IFB No. **16-05 Administration Building Renovations**

RE: **ADDENDUM NO. 1**

Changes to Bidding Documents Dated June 25, 2015

PROJECT: RENOVATIONS TO ADMINISTRATION BUILDING
ROCKFORD PUBLIC SCHOOL DISTRICT 205
ROCKFORD, ILLINOIS

1 ADDENDUM 1
SCALE: 1/16" = 1'-0"

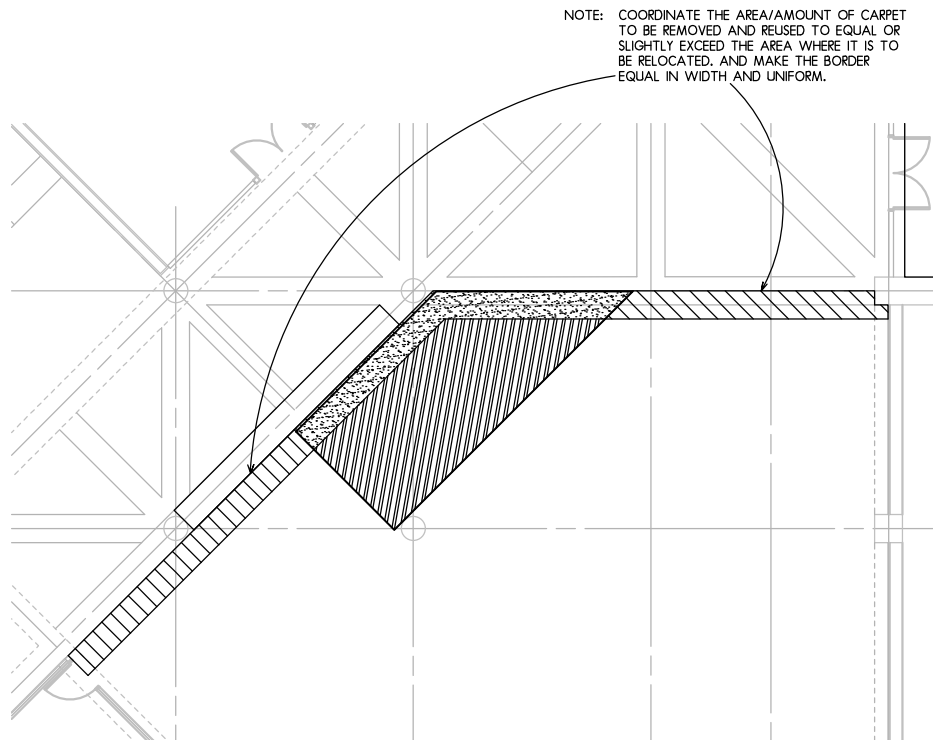
EXISTING CARPET TILE TO BE REMOVED AND SALVAGED FOR REUSE. INFILL WITH NEW BORDER CARPET TILE.

AREA TO ACCEPT REMOVED AND SALVAGED CARPET TILE TO MATCH REMAINING FIELD.

NEW BORDER CARPET AREA INFILL ALONG WITH BORDER AREA WHERE EXISTING CARPET WAS REMOVED FOR REUSE.

NOTE: NEW CARPET BORDER TO BE SELECTED FROM FULL RANGE OF "TANDUS" MATERIALS.
